Department of Transportation

MEMORANDUM

SUBJECT: ZC Case No. 19-23 – 80 M Street SE

Figure 1 | Site Plan (Source: Wells & Associates 12/20/19 Transportation Statement, Figure 5)

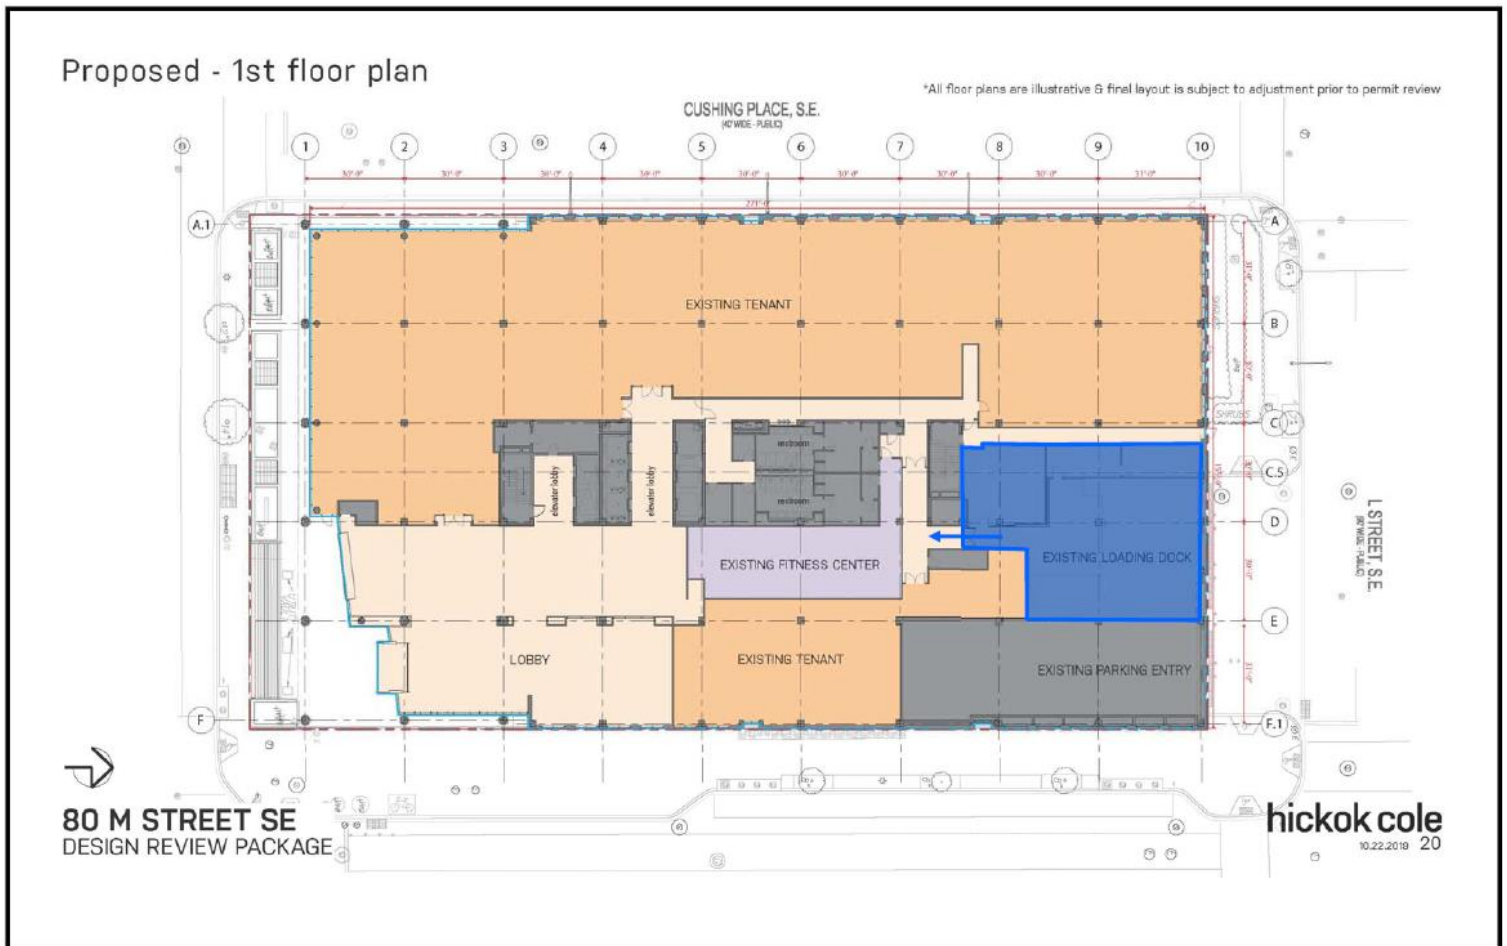
Vehicular access is provided via an existing large curb cut at the rear of the building on L Street SE. The curb cut also provides access to the loading dock. There is currently a gate installed at each of the entrance and exit lanes to the underground parking garage. The arm controlling the entrance to the garage is set back about one (1) car length internal to the building to minimize queueing back into public space. Primary pedestrian access will be modified but will remain in the southeast corner of the building at the corner of M Street and 1st Street SE. Figure 1 below shows the proposed site layout.

The site currently has three (3) loading docks that are access from the large curb cut at the rear of the property (see Figure 1 above). No changes are proposed to the existing loading configuration, but the Applicant is proposing to implement a Loading Management Plan (LMP) to address the existing back-in loading condition that does not meet modern DDOT standards. DDOT concurs with the following proposed LMP and requests it be included as a condition of approval in the Zoning Order:

- A loading dock manager will be designated by the building management who will be on duty during delivery hours. The dock manager will be responsible for coordinating with vendors and tenants to schedule deliveries and will work with the community and neighbors to resolve any conflicts should they arise;

- A lease provision will require all tenants to use only the loading area for all deliveries and move-in and move-out activities;
- All tenants will be required to schedule deliveries that utilize the loading area (any loading operation conducted using a truck 20-feet in length or larger);

- The dock manager will schedule deliveries using the berths such that the dock's capacity is not exceeded. In the event that an unscheduled delivery vehicle arrives while the dock is full, that driver will be directed to return at a later time when a berth will be available so as to not compromise safety or impede functionality;

- The dock manager will monitor inbound and outbound truck maneuvers and will ensure that trucks accessing the loading dock do not block vehicular, bike, or pedestrian traffic along L Street except during those times when a truck is actively entering or exiting a loading berth;
